PD 966

**Re: Minor Change to PD No. 966
Proposed Walmart Training Facility
8431 S. Stewart Avenue**

Re: **REVISED Administrative Relief request for Business Planned Development No. 966,
Parcel E2, Proposed Chase Bank at the Southeast corner of South Stewart Avenue
and West 83rd Street**

Re: **Administrative Relief request for Business Planned Development No. 966, Parcel E2, Proposed Chase Bank at the Southeast corner of South Stewart Avenue and West 83rd Street**

OVERALL SITE PLAN

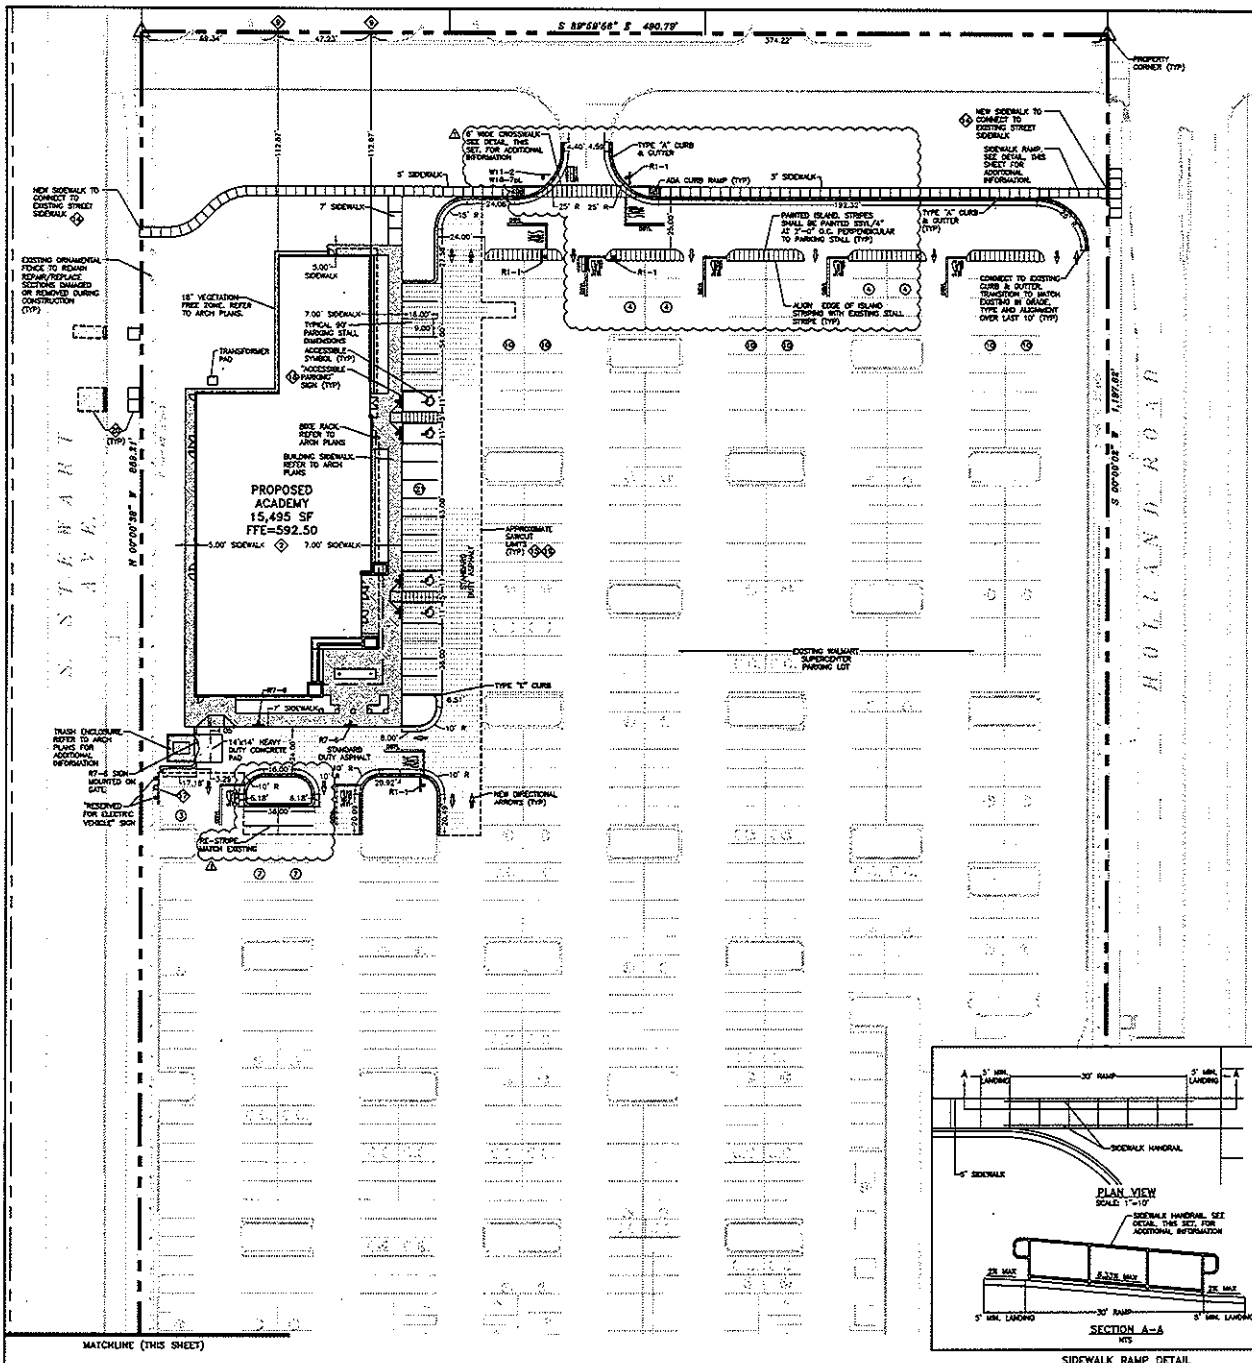
- Parking for the Walmart parcel will be reduced from 721 spaces to 604 spaces, and overall parking for the PD will be reduced from 1,717 to 1,600 spaces.
- Pursuant to Statements Number 15 and 16, you are seeking to replace the green roof and LEED certification with the requirements of the current Chicago Sustainable Development Policy.
- Pursuant to the Architectural Design Criteria for the Chatham Market, you are seeking to replace the required face brick with thin brick and to allow other modifications to the exterior wall design as shown on the attached exhibits.
- Pursuant to the PD's Signage Criteria, you are seeking approval of the two proposed signs as shown on the attached East Elevation and Signage Exhibit.

As part of this Minor Change the following attached drawings shall be inserted into the main file: Overall Site Plan, Site Plan, Planting Plan, Planting Details, Exterior Elevations, and Signage.

PROPOSED SITE PLAN

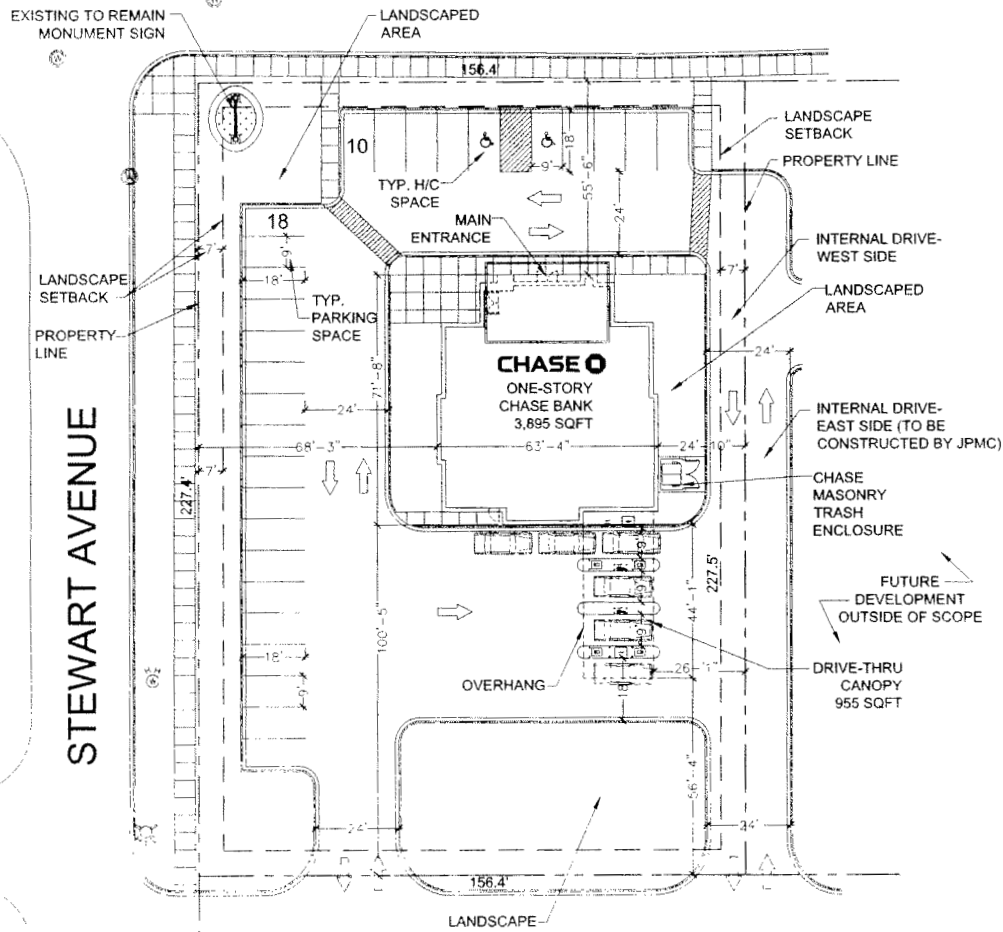
- Substitute the revised Site Plan, Landscape Plan, and Floor Plan, dated February 20, 2013 in place of the previously approved plans. It should be noted that Chase intends to construct the east side of the internal drive as reflected on the revised Site Plan. A portion of the internal drive is located outside the property line of Parcel E2 but within the PD. Additionally, the parking has been reduced from 35 spaces to 28 spaces.
- Increase the overall sign length from 16' -0" to 17'-7" to conform to Chase's standard sign length.
- Reduce the display window size from the required 8' by 10' to 6'-8" on the revised East and West Elevations.

ELEVATIONS

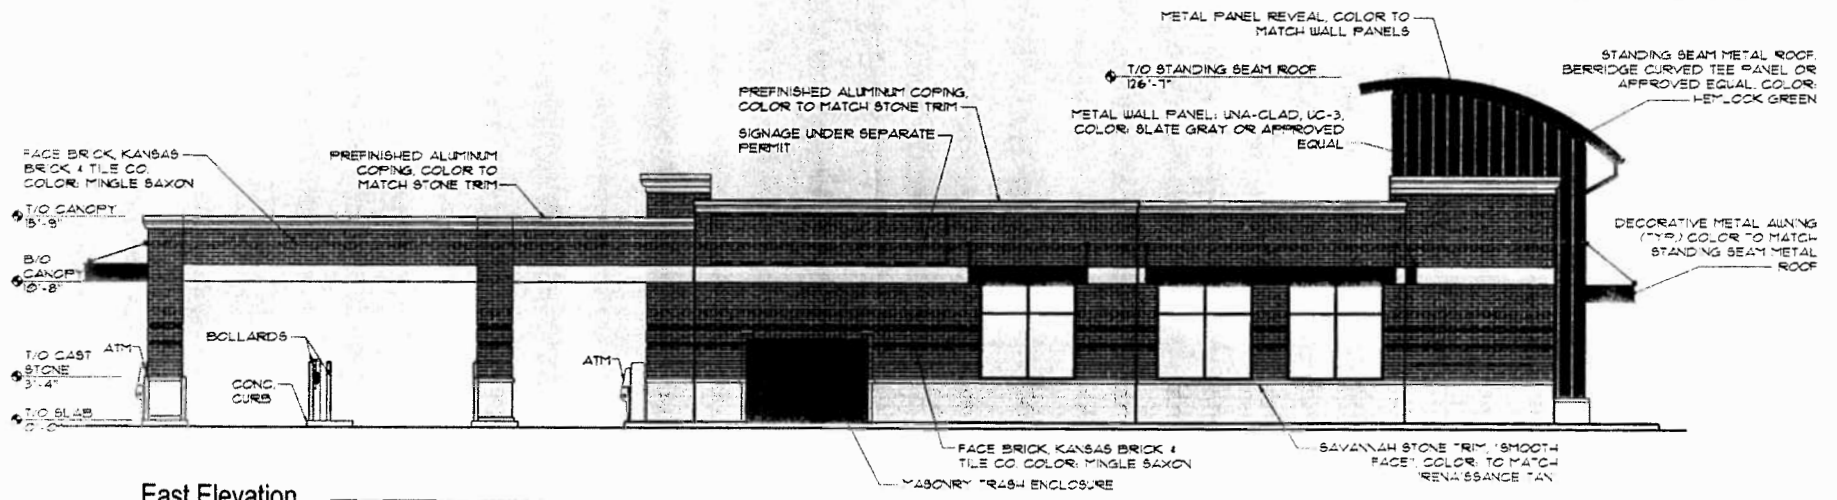
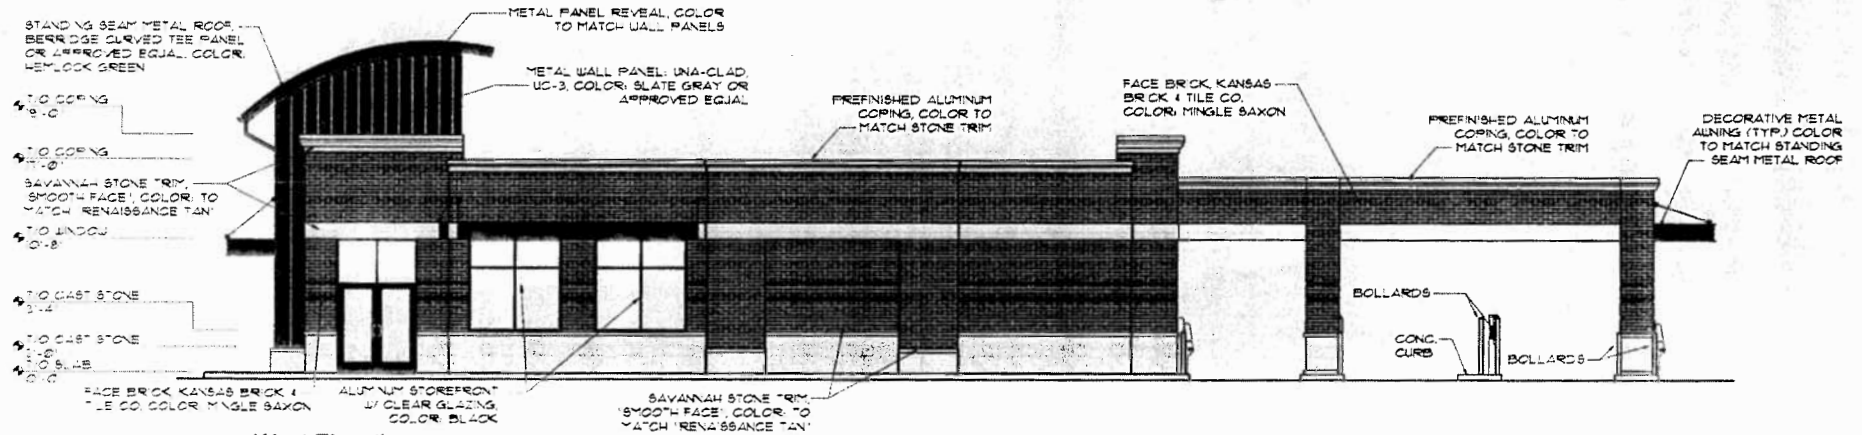
On March 11, 2013, we issued an administrative relief to allow site and design changes for your client, Chase Bank, at the above location. Included in this administrative relief was the reduction of the display window size from the required 8' x 10' to 6'- 8" x 6'- 8" on the East and West Elevations. However, your initial request contained a typographical error and you are now seeking a correction in the revised dimension from the required 8' x 10' to 6'- 0" x 6'- 8" on the East and West elevations.

- Increase the main entry and branding architectural features occupying the primary façade from 30% to 47% as shown on the revised North Elevation.
- Substitute Savannah Cast Stone in place of Renaissance Stone. Revised North, South, East and West Building Elevations, dated February 20, 2013 shall be inserted into the main file.

Accordingly, pursuant to the authority granted by the Chicago Zoning Ordinance and Business Planned Development No. 966, I hereby approve the foregoing minor change, but no other changes to this Planned Development.

MSI HOSPITALITY SOLUTIONS OF CHICAGO
MOTEL SLEEPERS, INC.
ADDRESS
FRONT AND REAR ELEVATIONS

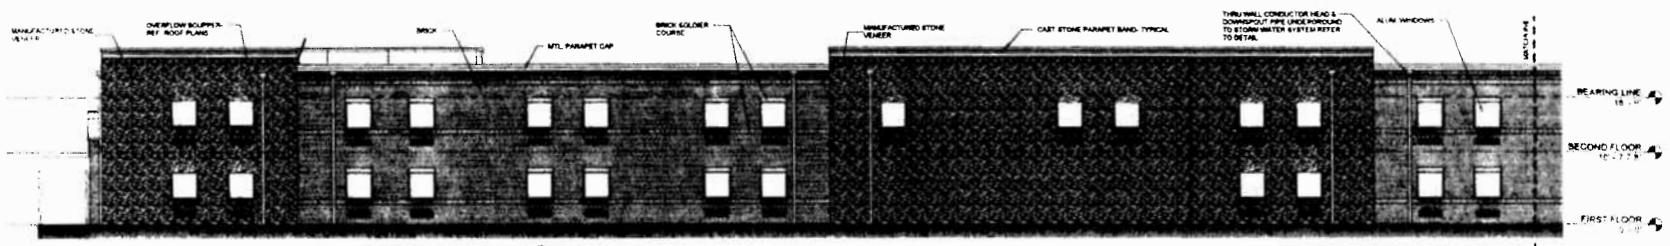
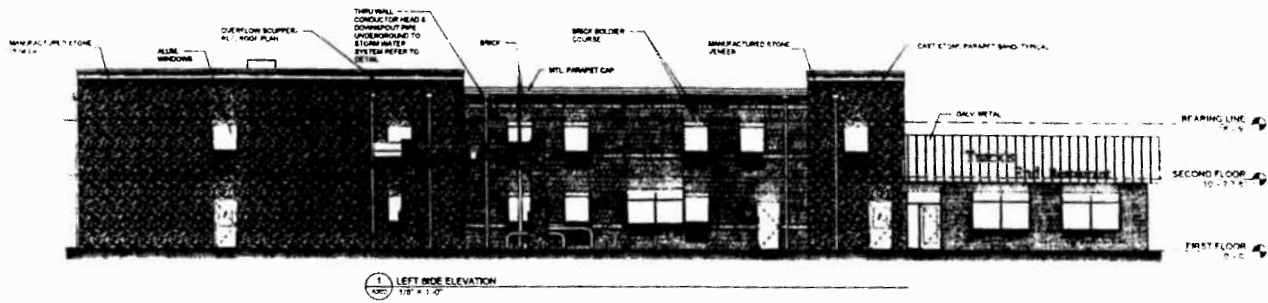
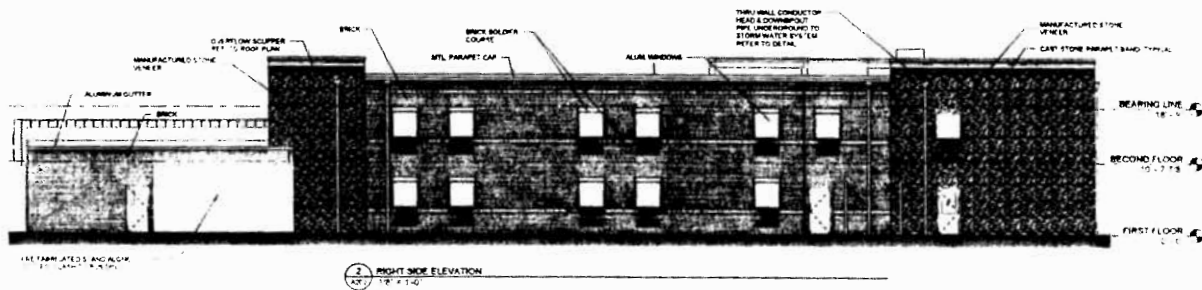
Please be advised that your request for a minor change to Business Planned Development No. 966 has been considered by the Department of Housing and Economic Development pursuant to Section 17-13-0611 of the Chicago Zoning Ordinance and Statement No. 17 of the Planned Development (PD).

Accordingly, pursuant to the authority granted by the Chicago Zoning Ordinance and Business Planned Development No. 966, I hereby approve the foregoing minor change, but no other changes to this Planned Development.
